Preliminary Consultation
MONTGOMERY COUNTY HISTORIC PRESERVATION COMMISSION
STAFF REPORT

Address:	7130 Carroll Avenue, Takoma Park	Meeting Date:	9/3/2025
Resource:	Contributing Resource Takoma Park Historic District	Report Date:	8/27/2025
Applicant:	Antonios Tontisakis (Jennifer Goon, Agent)	Public Notice:	8/20/2025
Review:	Preliminary Consultation	Tax Credit:	No
Permit Number:	1115772	Staff:	Devon Murtha
PROPOSAL: Window alterations and retroactive awning removal

Figure 5: Sample profiles of the Marvin Elevate windows to be installed.

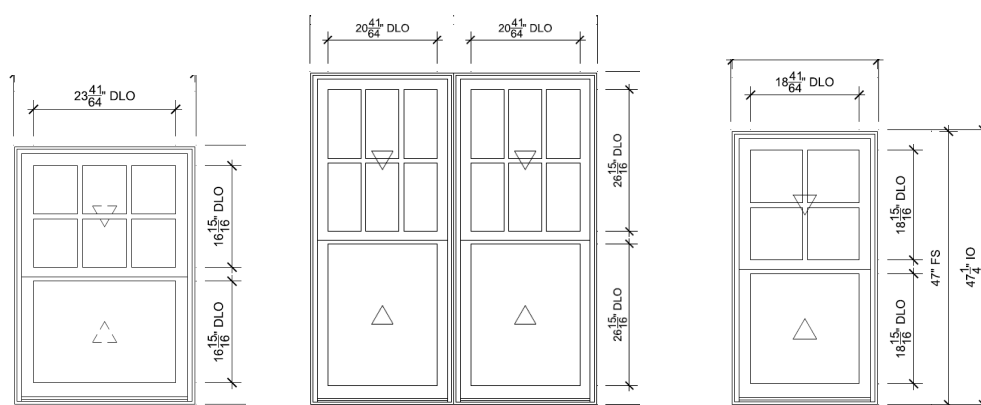
The applicant has provided Staff with samples of this product, and in this case, Staff finds that the profiles and detailing of the proposed Marvin Elevate windows are consistent with the overall appearance of a historic double-hung windows from this period, with some minor exceptions (*Figure 9*). The muntin profiles have a putty slope that mirrors the overall appearance of a glazed wood window. The Marvin Elevate fiberglass-clad windows have a matte finish, rather than a reflective one, and are paintable. The bottom rail appears to be lightly shorter than a traditionally historic wood window; however, Staff finds that this detail will likely not discernable from the right-of-way along Carroll Avenue, especially on the side and rear elevations.

LIVING ROOM MIDDLE

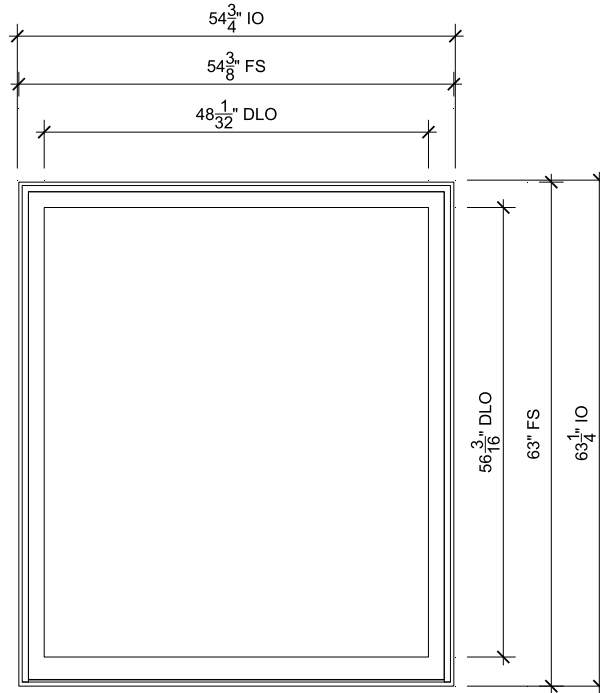
The applicant is also proposing to install one (1) fiberglass-clad picture windows. The historic photograph shows that window opening originally held two paired windows, although Staff is not able to determine the window type from the photo (*Figure 12*). The applicant is proposing to install a new large fiberglass-clad picture windows to match the existing dimensions. Staff is seeking feedback from the HPC on the appropriateness of this window.

The *Guidelines* state that exterior alterations to contributing resources, “should be generally consistent with the predominant architectural style and period of the resource and should preserve the predominant architectural features of the resource; exact replication of existing details and features is, however, not required.” While Staff does not find it necessary to replicate the exact profile of the window from the historic photo, Staff finds that a large picture window is not consistent with the architectural style of an early twentieth century bungalow. Bungalows from this period typically featured double-hung wood windows with a variety of profiles. Although not unheard of, a large picture window would have been an atypical design choice for this resource.

In determining what would be a compatible replacement, Staff looked to the pre-existing window condition at the subject property in addition to surrounding resources as examples. The vast majority of early twentieth century bungalows on the 7300 block of Carroll Avenue, and the surrounding blocks, feature single or ganged double hung windows in the larger window openings. Staff recommends that the applicant amend their proposal for this opening to hold paired double-hung windows, as opposed to a large picture window, in order to be more consistent with the resource and the district.

Staff recommends that the applicant make any revisions based upon the HPC's comments and to work with Montgomery Planning staff to determine the appropriate next steps to return for a HAWP. Staff also recommends that the applicant submit accurately dimensioned shop drawings to staff, showing how the inserts will be installed within the existing historic wood frames
